Topic	Rear armrest - Incorrect specification (SC24/31)
Market area	Germany E02 Bentley rest Europe (6E02),Japan E03 Bentley Japan (6E03),United States E05 Bentley USA and rest America (6E05)
Brand	Bentley
Transaction No.	2075974/1
Campaign number	ED24
Note	
Type	
US code

Bentayga Series

Figure 9

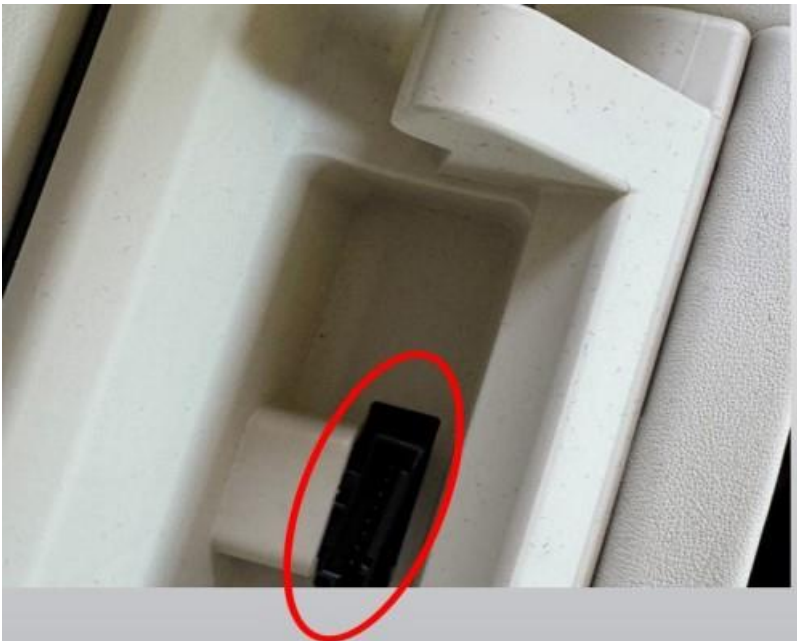
5) Locate the new armrest and locate the plug (Figure 9)
